NEW YORK STATE THRUWAY AUTHORITY  
DEPARTMENT OF ENGINEERING

AMENDMENT NO. 1  
TO

CONTRACT TAN 16-32B  
D 214503  
REHABILITATION OF THE NORTHBOUND AND SOUTHBOUND  
NORTH GRAND ISLAND BRIDGE & ROBERT MOSES OFF-RAMP  
AT MP N20.35, N 21.12 & N21.11  
IN THE BUFFALO DIVISION  
OF THE NEW YORK STATE THRUWAY  
IN ERIE AND NIAGARA COUNTIES

IN THE LETTING OF  
OCTOBER 5, 2016

<b>Thruway Authority</b>   <b>Canal Corporation</b>	TITLE OF PROJECT REHABILITATION OF NORTHBOUND NORTH GRAND ISLAND BRIDGE	CONTRACT NUMBER: TAN 16-32B
	LOCATION OF PROJECT M.P. N20.35, N21.11 & N21.12	DATE: SEPT., 2016
	TITLE OF DRAWING GENERAL NOTES - 2	DRAWING NUMBER: GN-2

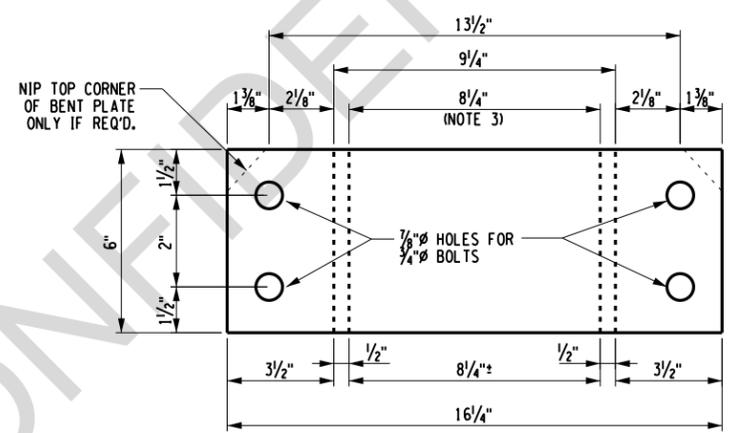
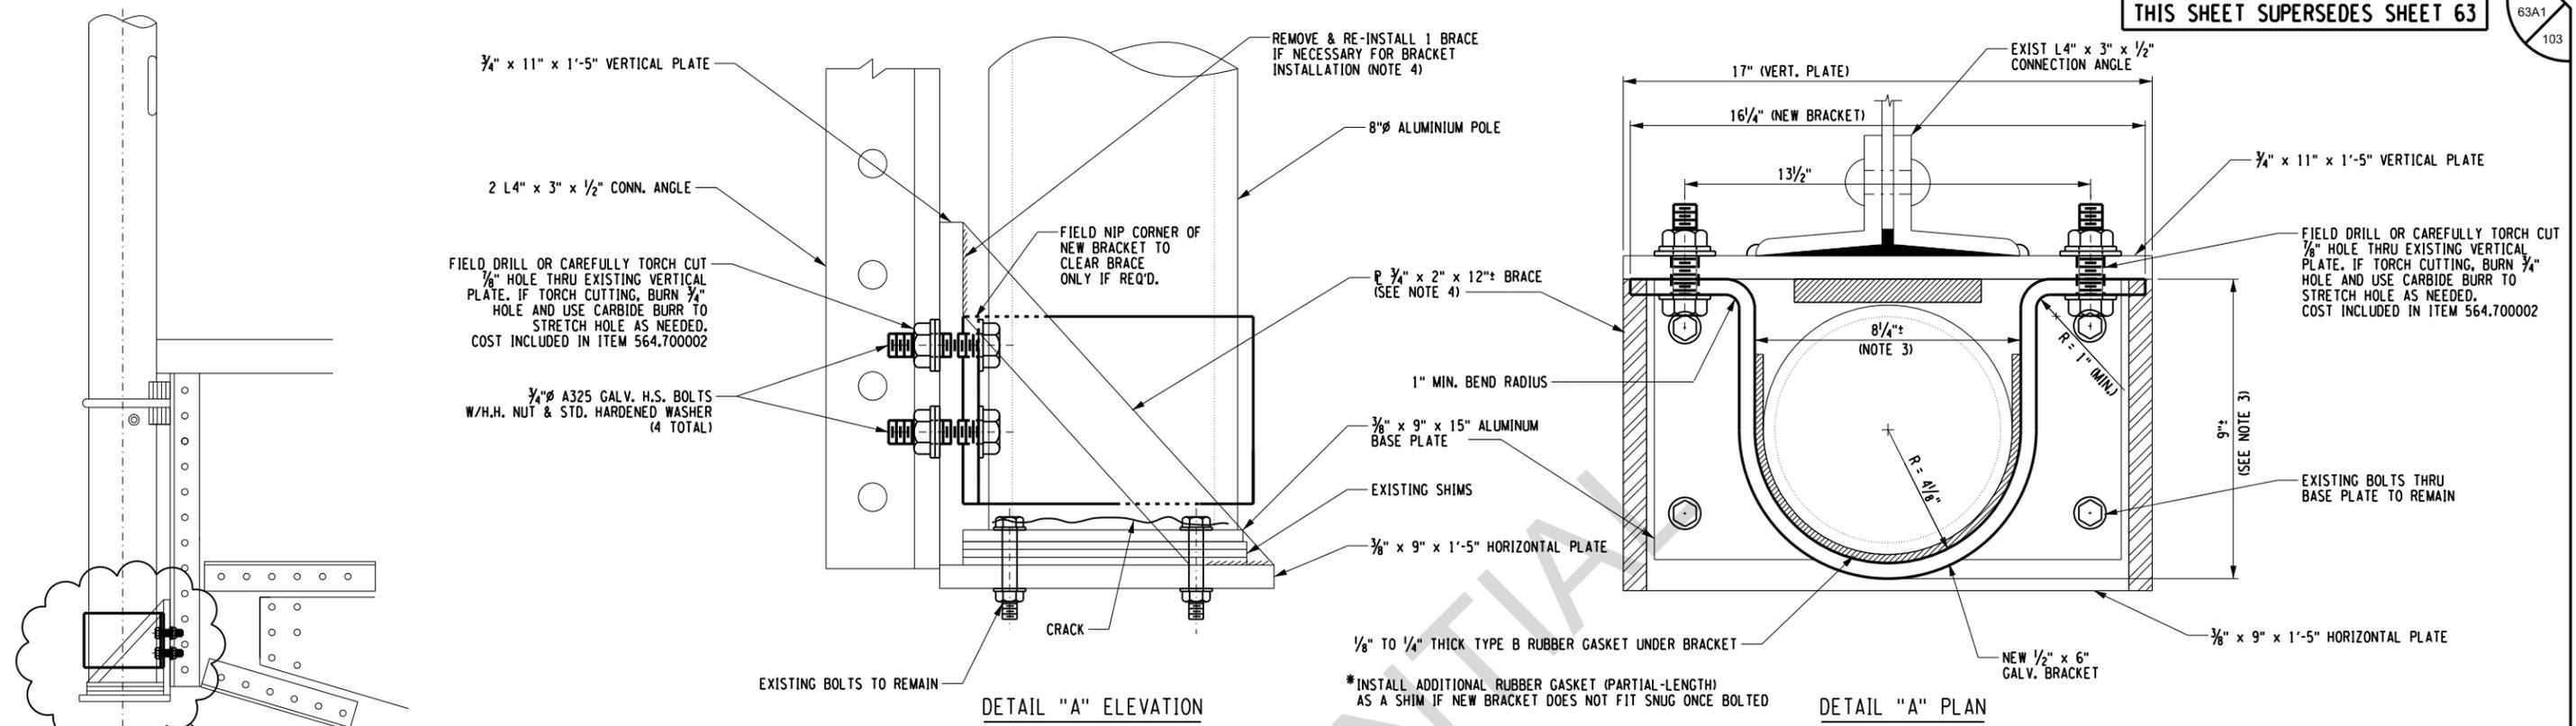
2. **DELETE** Drawing GN-2, Sheet 6, and **SUBSTITUTE** the attached Drawing GN-2, Sheet 6-A1. Note 2 under Work Restrictions has been revised and Notes 1 and 2 have been added under High Priority Items.
3. On Drawing JD-15, Sheet 59, **REVISE** the paragraph under "Modular Joint Installation Sequence" Note 10 to read "The temporary ramps shall be in place at all times when the bridge is open to traffic. Remove the ramps during the nightly work shift that the rapid setting concrete header is placed."
4. **DELETE** Drawing STR-1, Sheet 63, and **SUBSTITUTE** the attached Drawing STR-1, Sheet 63-A1. Stainless Steel brackets will be omitted and replaced with Galvanized Steel Brackets. Notes 1, 3 and 4 have also been revised.

**WORK RESTRICTIONS**

- THE CONTRACTOR SHALL UTILIZE THE LANE DESIGNATION SIGNALS ON THE NORTH GRAND ISLAND BRIDGE, SOUTHBOUND (NGIB-SB), AND CONFIRM WITH THE NYSTA THAT THEY ARE FULLY FUNCTIONING, BEFORE NIGHTLY BRIDGE CLOSURES WILL BE PERMITTED ON THE NORTHBOUND BRIDGE FOR THE PURPOSES OF BRIDGE DECK OVERLAY. ALL PERMANENT "OBEY LANE SIGNALS" AND "STAY IN LANE" SIGNS ON THE NGIB (SOUTHBOUND) SHALL BE INSTALLED BEFORE ANY NGIB (NORTHBOUND) SHUTDOWN. SEE DWGS. SIGN-1 & SIGN-2.

- THE CONTRACTOR WILL BE ALLOWED TO CLOSE THE NORTH GRAND ISLAND BRIDGE, NORTHBOUND (NGIB-NB) TO ALL TRAFFIC PREVIOUSLY DEFINED IN WORK ZONE TRAFFIC CONTROL, NOTE 1) DURING THE 2017 CONSTRUCTION SEASON ONLY, TO COMPLETE THE PARTIAL & FULL-DEPTH DECK REPAIRS, JOINT REMOVAL & INSTALLATION OF NEW JOINTS, SCUPPER ADJUSTMENTS, BRIDGE GUIDE RAIL REPLACEMENTS, CONSTRUCTION OF SOUTH ABUTMENT APPROACH SLAB AND POLYESTER OVERLAY OF THE CONCRETE DECK. TO CLOSE THE NGIB-NB, TRAFFIC CONTROL DEVICES, AS DETAILED IN THE PLANS, SHALL BE SET UP NIGHTLY TO ALLOW TWO-WAY, SINGLE LANE TRAFFIC ON THE NORTH GRAND ISLAND BRIDGE, SOUTHBOUND. THE CONTRACTOR SHALL REQUEST APPROVAL FOR BRIDGE CLOSURES FOR ALL OTHER WORK NOT RELATED TO THE POLYESTER OVERLAY.

**HIGH PRIORITY ITEMS**

- THE STRINGER WEB REPAIRS (ITEM 564.700003) FOR THE SOUTHBOUND BRIDGE ARE CONSIDERED HIGH PRIORITY. ALL STRINGER WEB REPAIRS LISTED ON DWG. STR-7 ARE TO BE COMPLETED BY MAY 12, 2017.
- THE LOCALIZED PAINTING OF SEVERAL GUSSET PLATES (ITEM 574.030001) ARE CONSIDERED HIGH PRIORITY ITEMS. THE FOLLOWING 4 GUSSET PLATES MUST BE FULLY CLEANED AND PAINTED PRIOR TO MAY 26, 2017:
  - L11 - WEST TRUSS
  - L25 - EAST TRUSS
  - L127 - WEST TRUSS
  - L137 - WEST TRUSS
 OTHER GUSSET PLATES MAY ALSO BE WORKED ON PRIOR TO THAT TIME TO SUIT THE CONTRACTOR'S ORDER/SEQUENCE OF OPERATIONS.
